WILLIAMS ELECTRONIC MFG. CORP.			
8401 N. CALIFORNIA		CHICAGO 18, ILL. CORNELIA 7-2840	
NAME	SOUND BOARD	ASSEMBLY	
MATERIAL		HEAT TREATMENT	FINISH
DATE	4-8-78	APPR.	SCALE 2:1
DRN	R. G. H.		D-8066

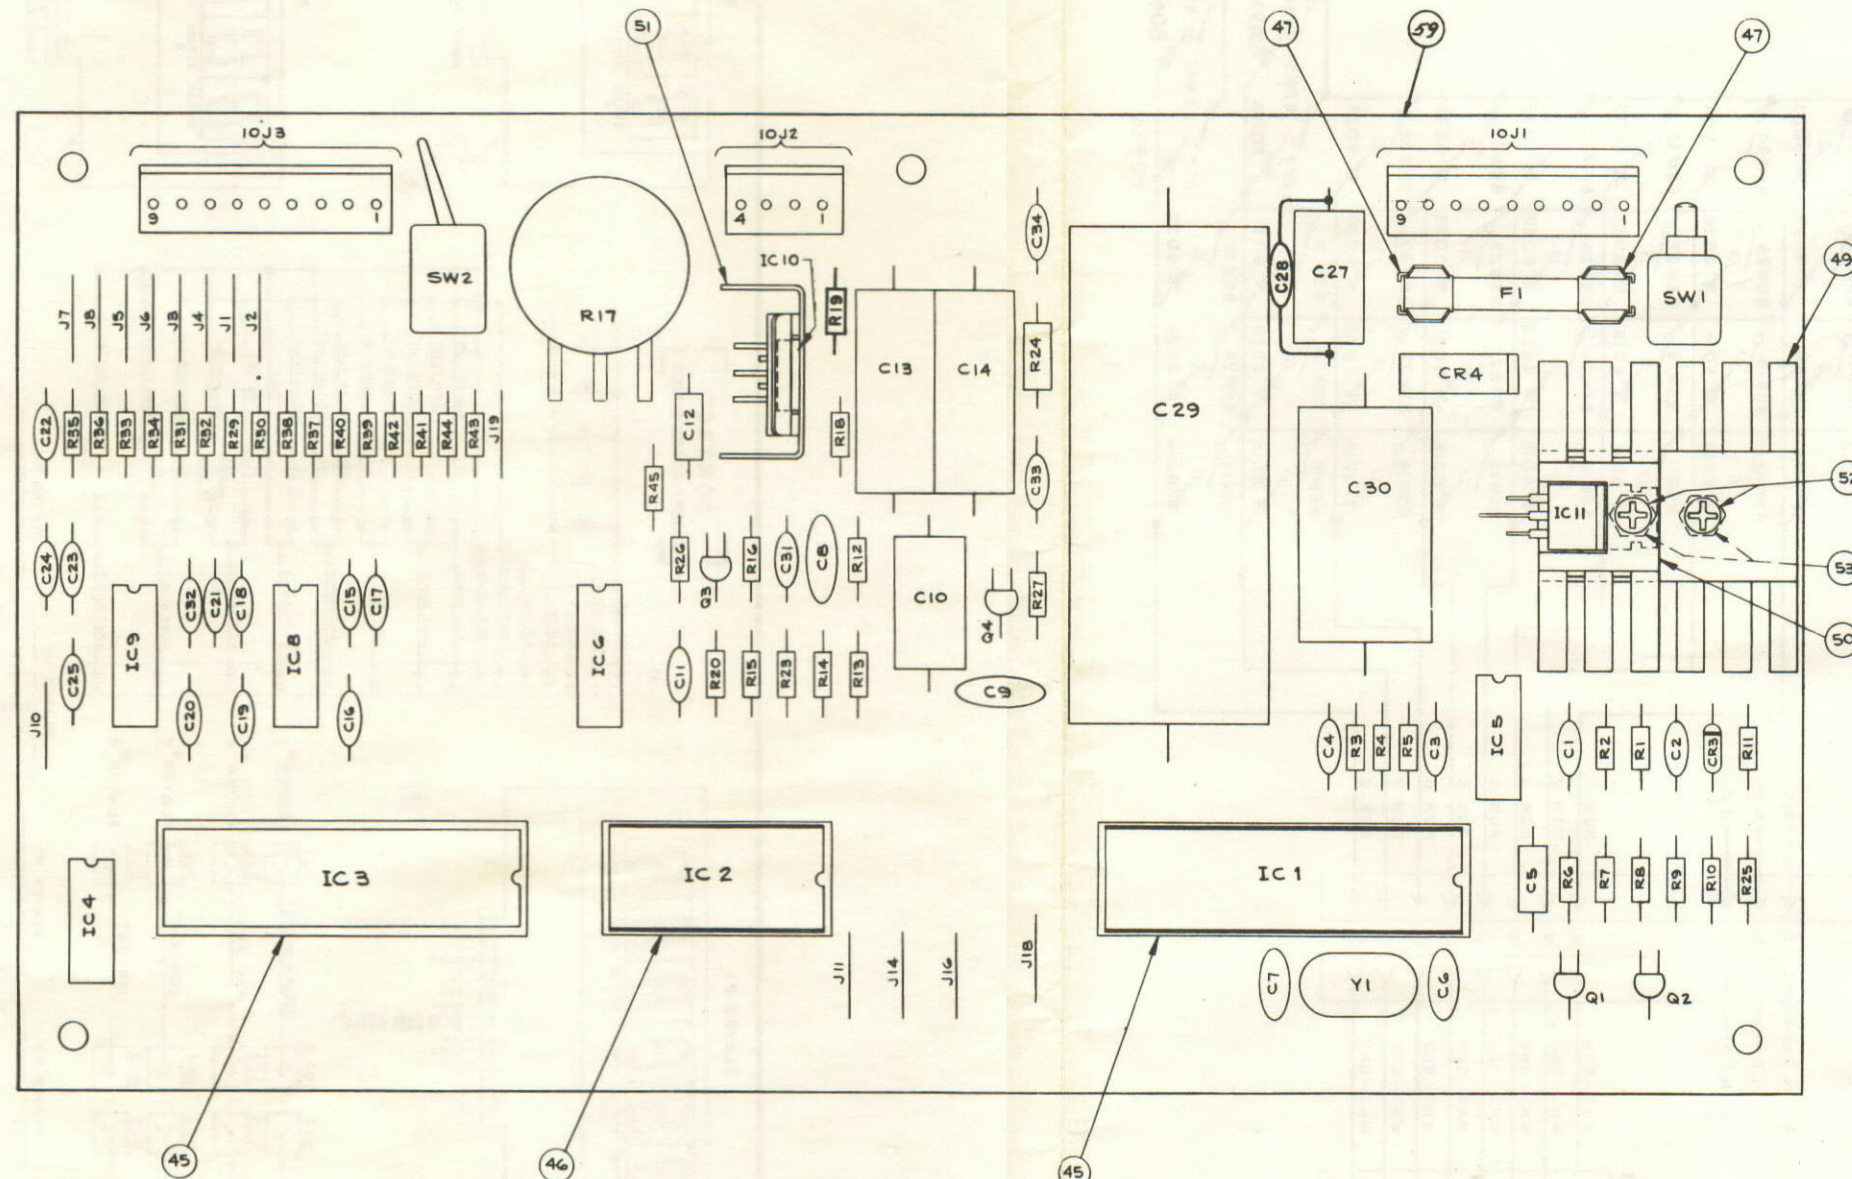
IN ITEM #7 DELETED IC7 (PT NO. 5A-8974); ITEM #36 DELETED C26; ITEM #21, DELETED R19; ITEM #26, DELETED R21 & R22 & ITEM #13 DELETED CR1 & CR2 (PT NO. 5A-9019)	R. G. H. 4-19-78
REVISION	BY
